ADDENDUM No. 1

DATE: November 22, 2024

PROJECT: Village of Algonquin
Braewood Pump Station Rehabilitation

TAI PROJECT NUMBER: ALG-037

Electrical Demolition: One-Line Diagram

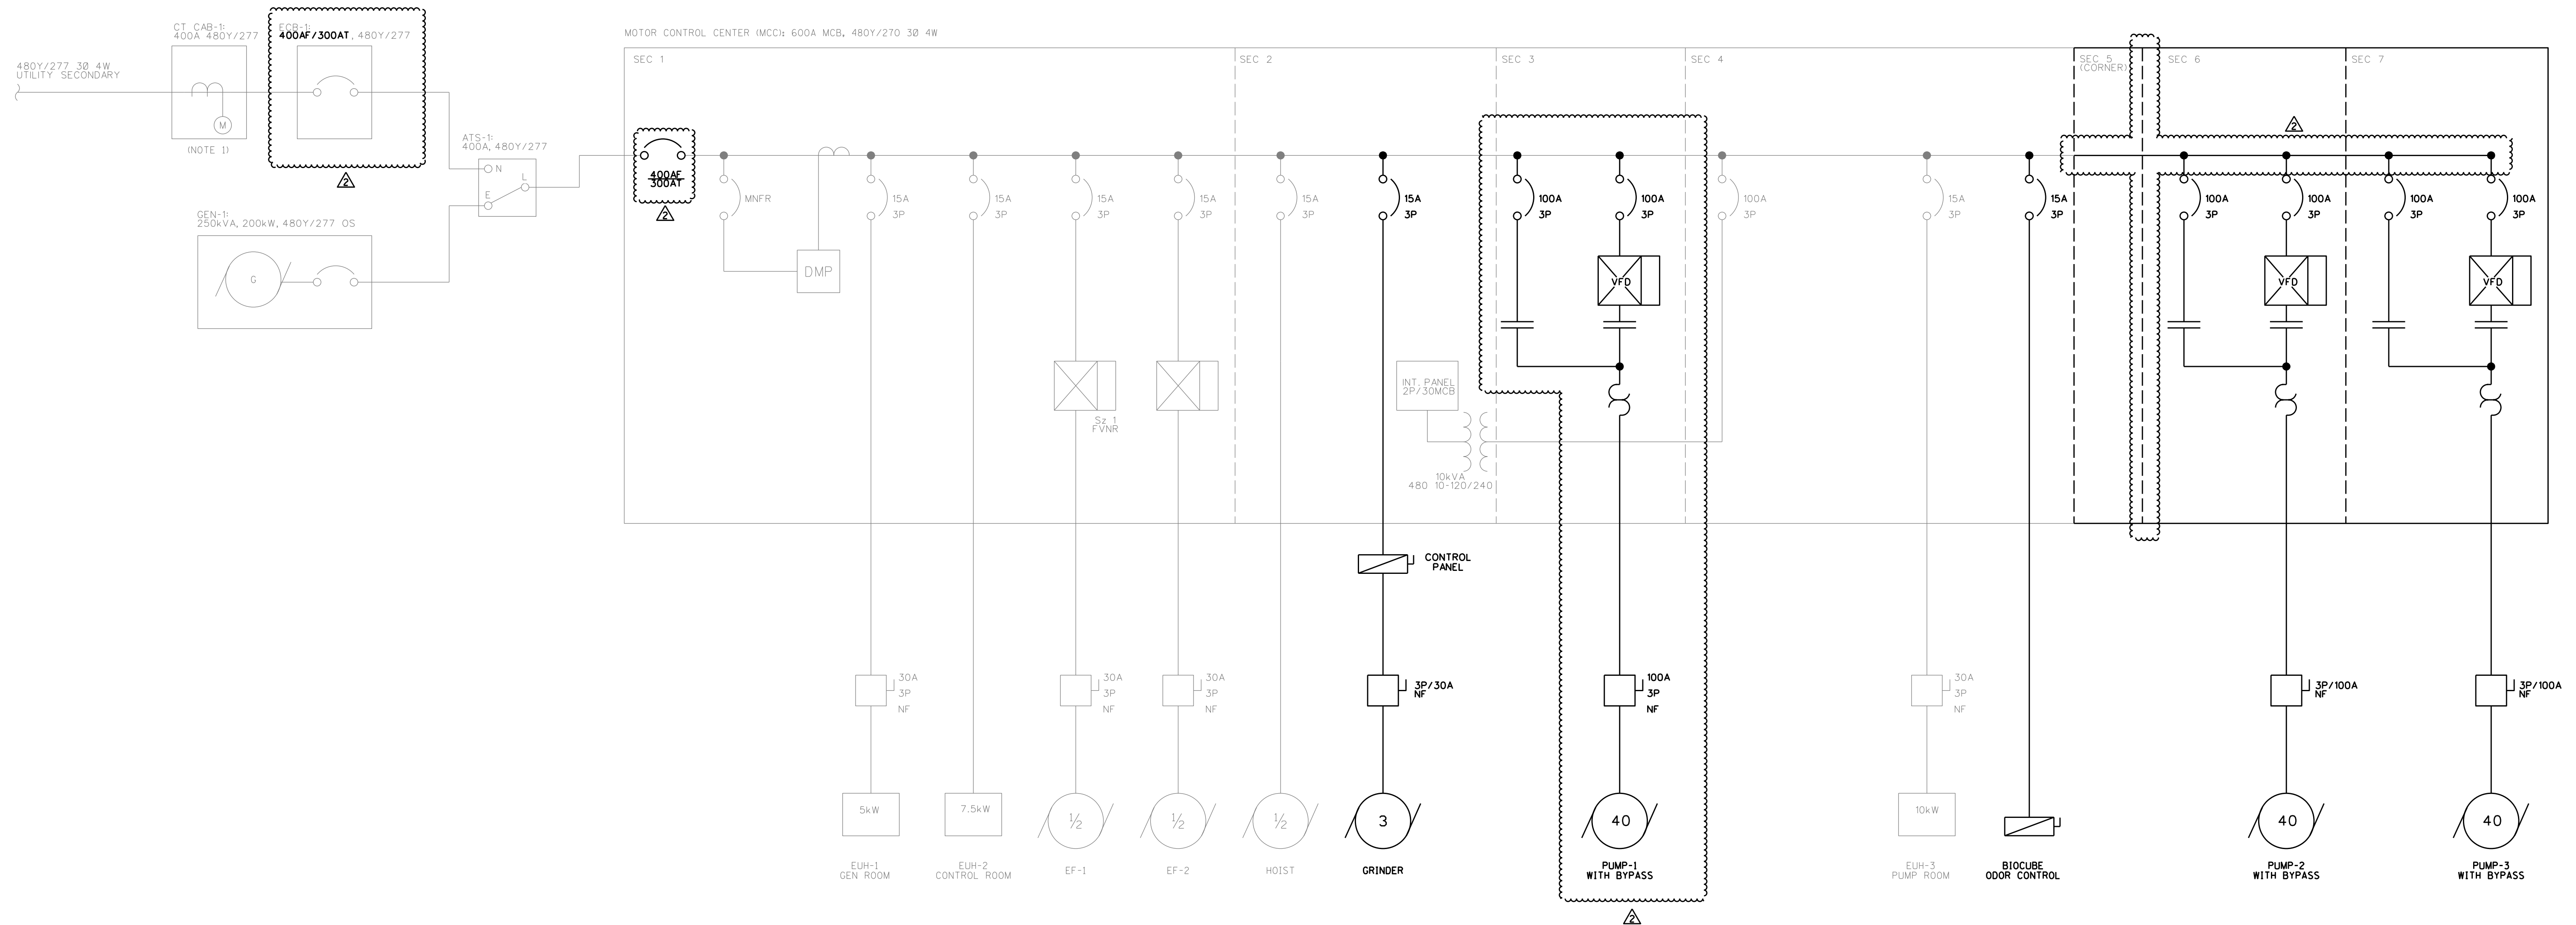
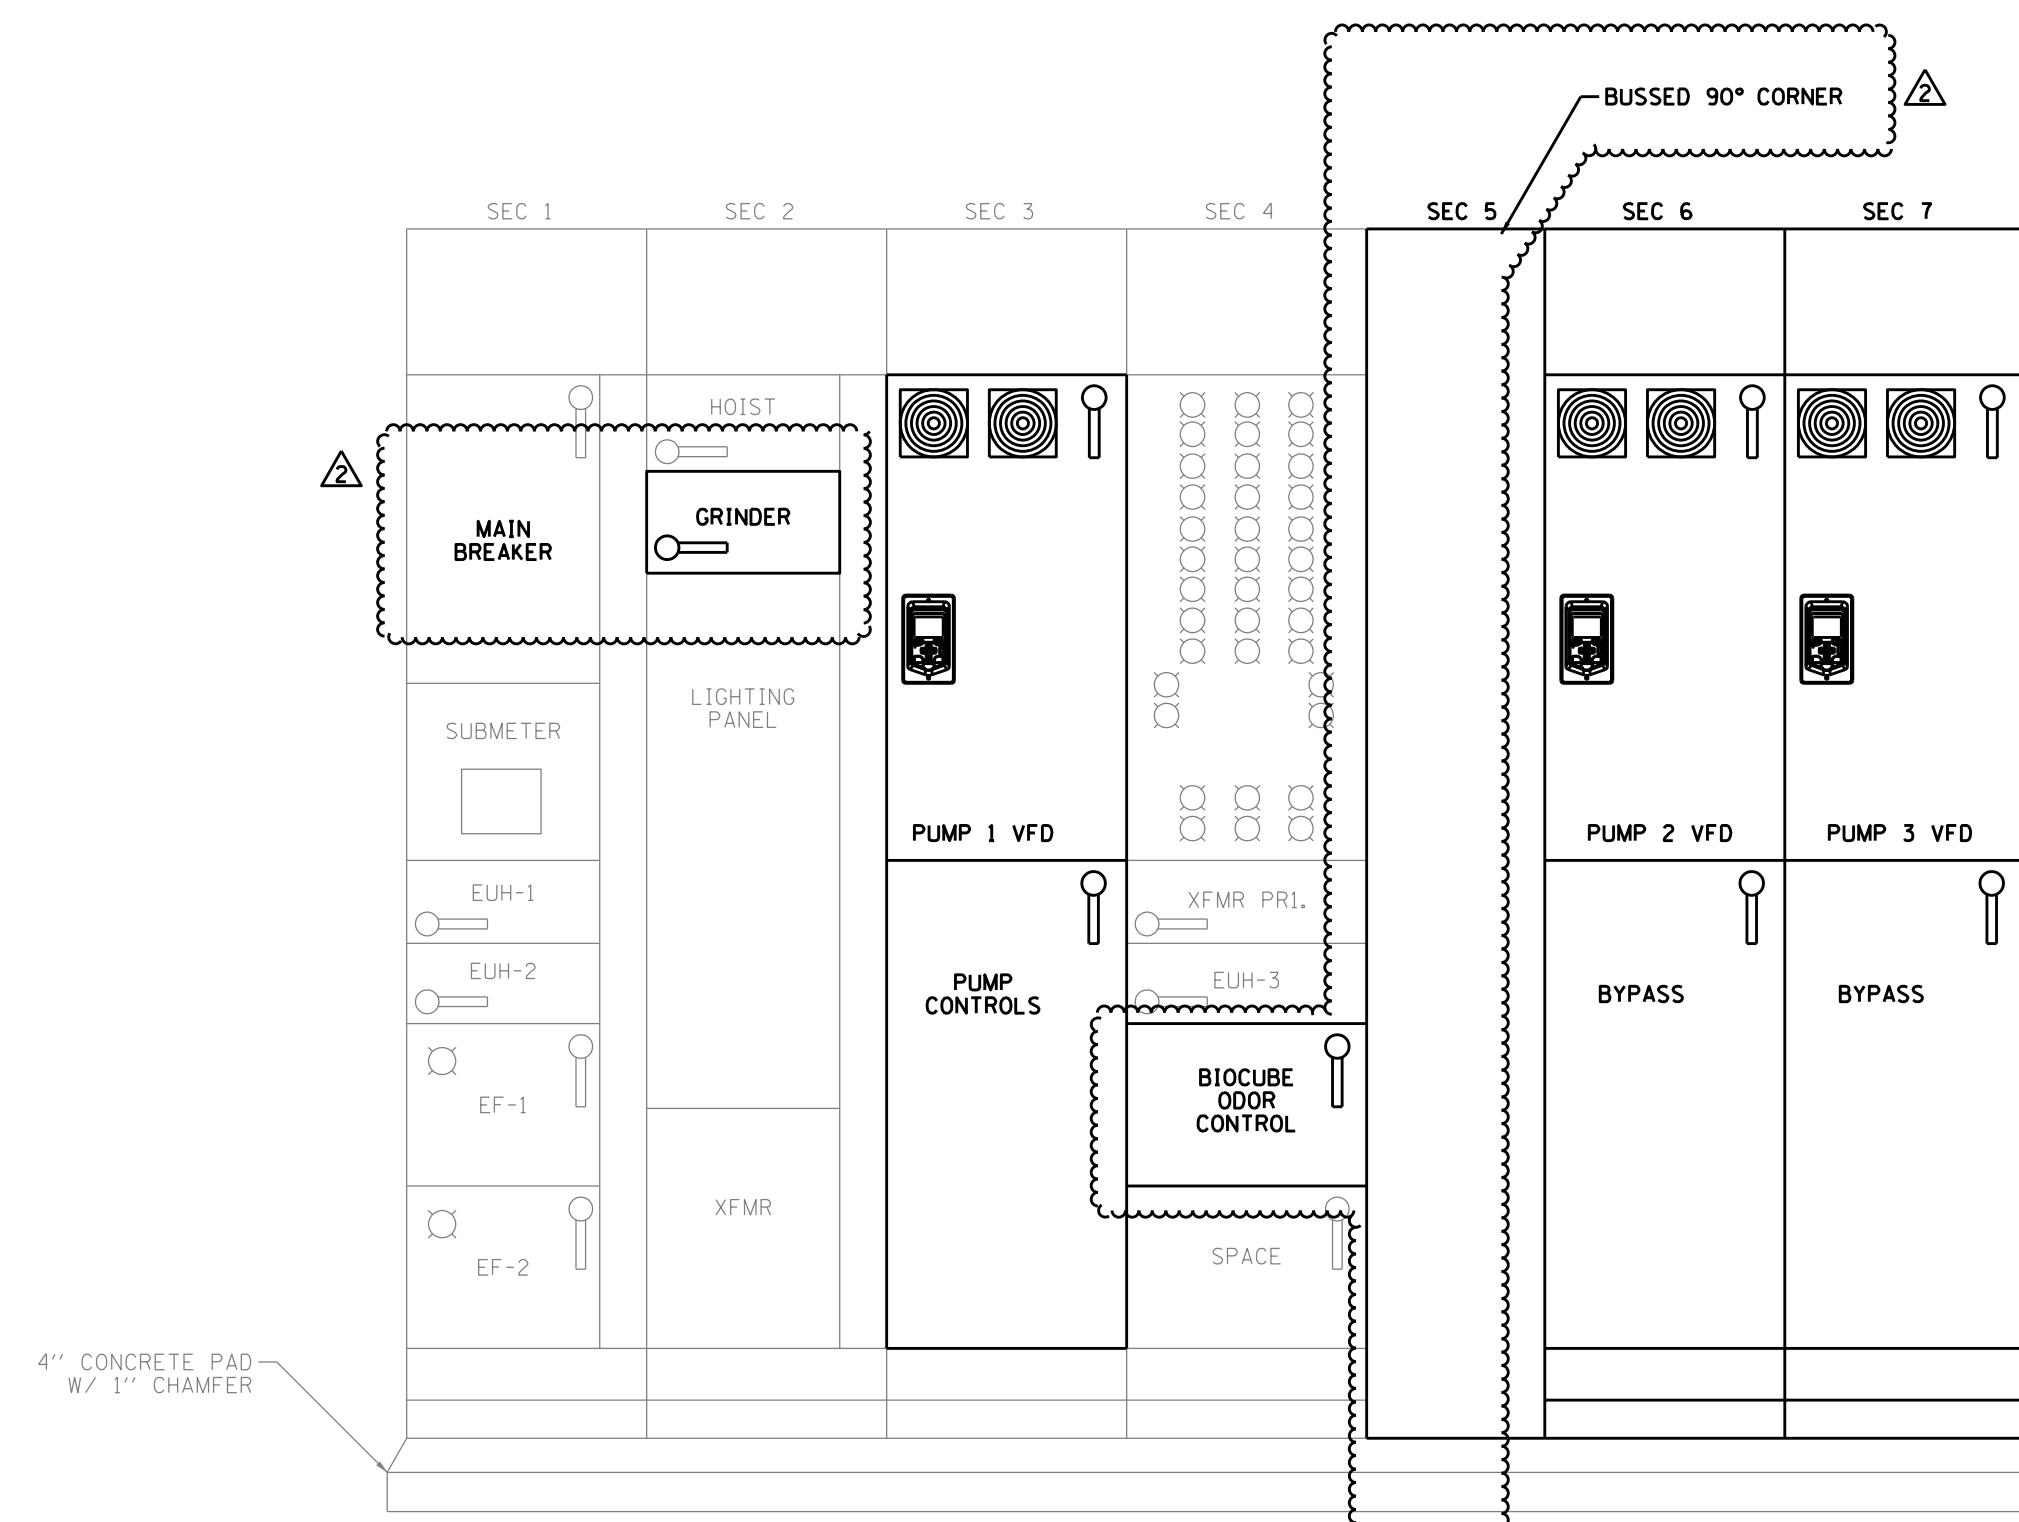
4. Sheet D.5 – Electrical Single-Line and MCC Elevation Demolition

- A. MCC sections 5, 6 and 7 to be removed.
- B. Buckets associated with Pump 1 to be removed in Section 3.
- C. Various changes for consistency/clarity

Braewood Pump Station Rehabilitation
Site Plan
Algonquin, Kane County, Illinois

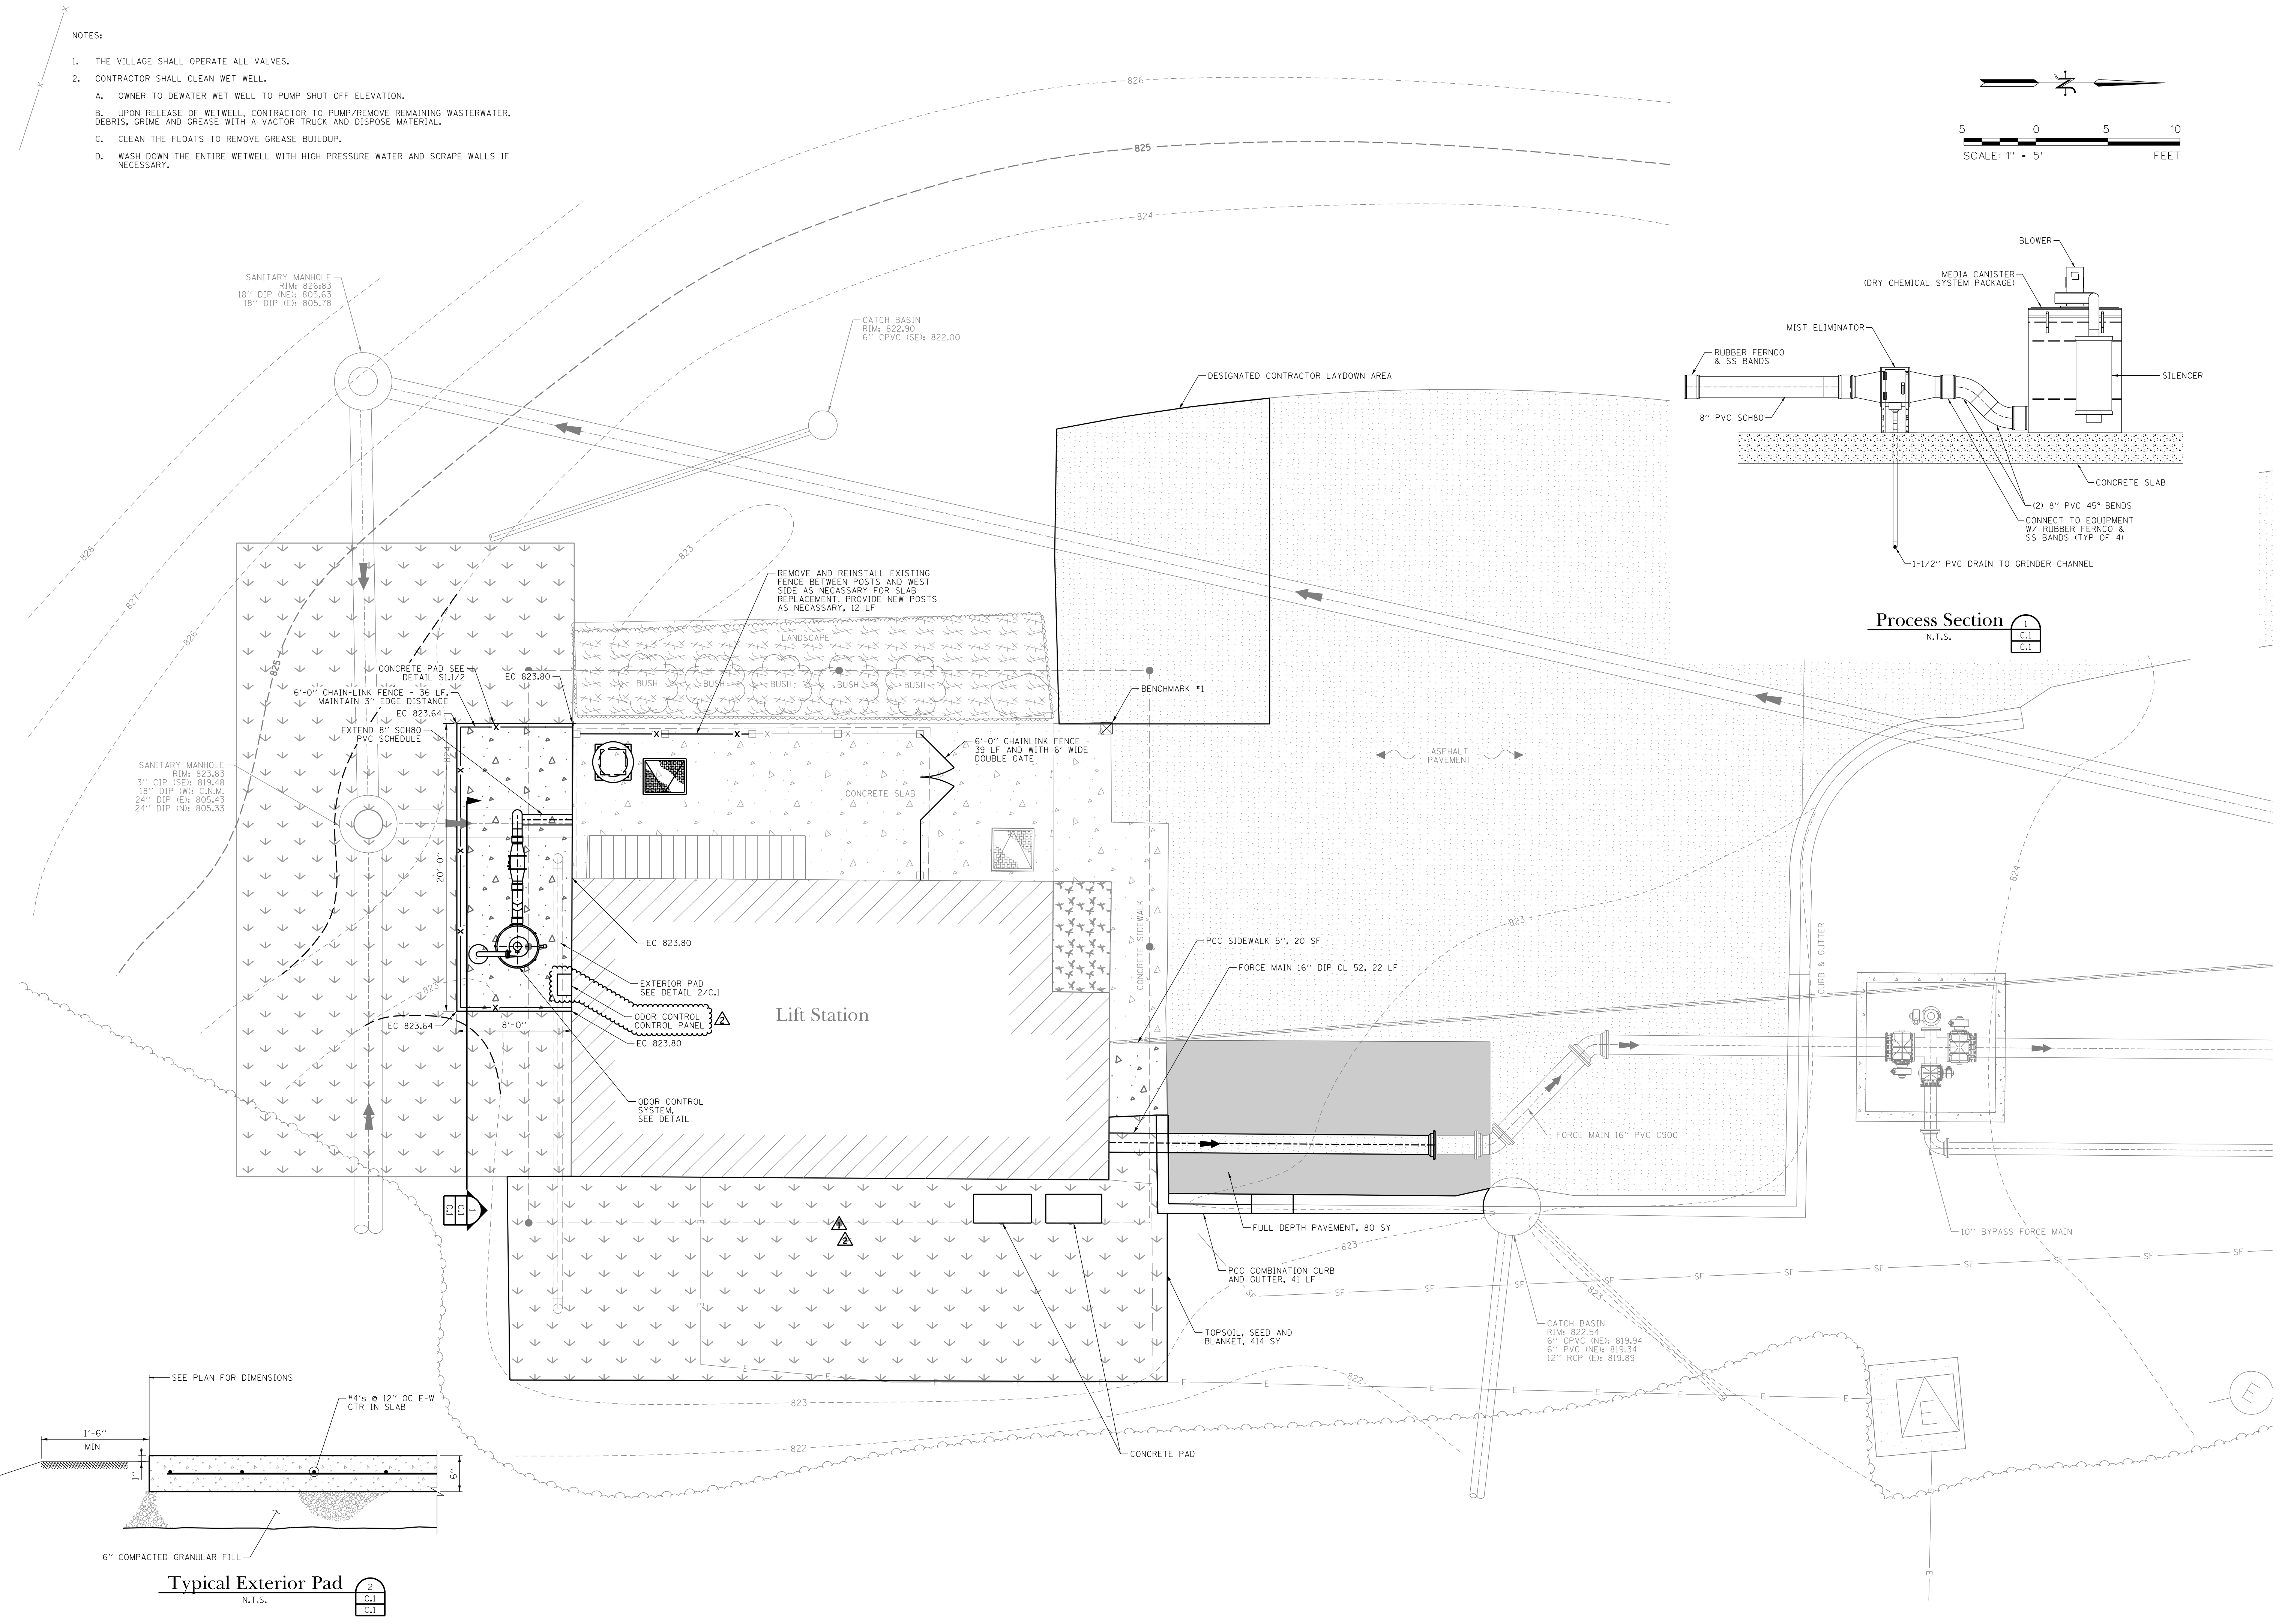
2. Should the cost to repair the asphalt at the “Designated Contractor Laydown Area” be included in the proposal?

Response: Contractor to restore the site to its original condition. Sheet C.1 has been revised to include limits to which the Contractor must keep their work within to minimize the area of restoration.
